Royal Prince Alfred Hospital North West Precinct Redevelopment

SECTION 75W APPLICATION

Architectural Design Statement

Document Reference: 3599-0603-012

Figure 3.1.1 Previous and current designs for ground level entry and vehicle drop off

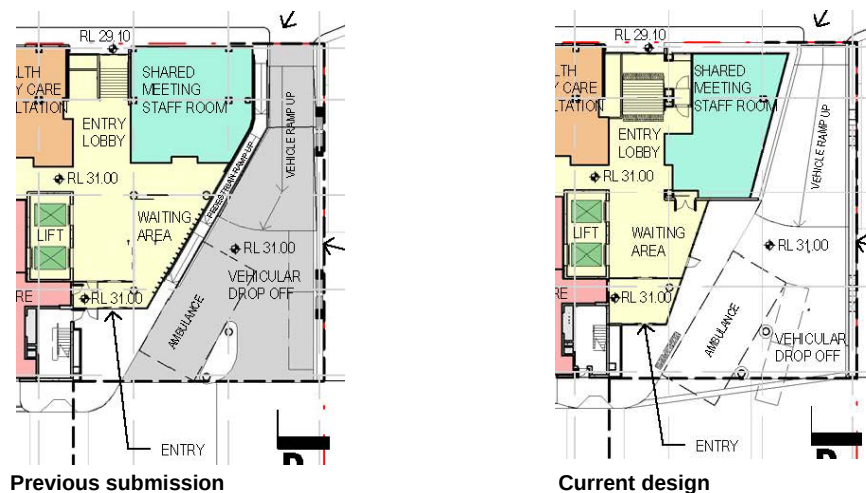
As part of design development, the disabled access ramp from Lucas Street was reconsidered in consultation with the DDA consultant and substituted for a disabled platform lift at the Lucas Street entry. This solution was considered for the following reasons:

- The setdown and structural profile of the disabled ramp had a significant impact on height clearances at the lower ground level, limiting vehicular movement and the use of the north-east corner of the car park;
- To create a centralised Lucas Street entrance for all visitors, patients and staff, regardless of their level of mobility;
- To separate pedestrian movement from the vehicular access ramp and entry;
- To provide a more efficient configuration of the vehicle drop off area, in particular increasing the proportion of the off-loading area and entry of patients from the ambulance/patient transport vehicles; and
- A rationalisation of access to the building, promoting a through link between Brodie Street and Lucas Street.

This response, as outlined, has meant some minor modification and rationalisation of the façade extent at ground floor level and level 1.
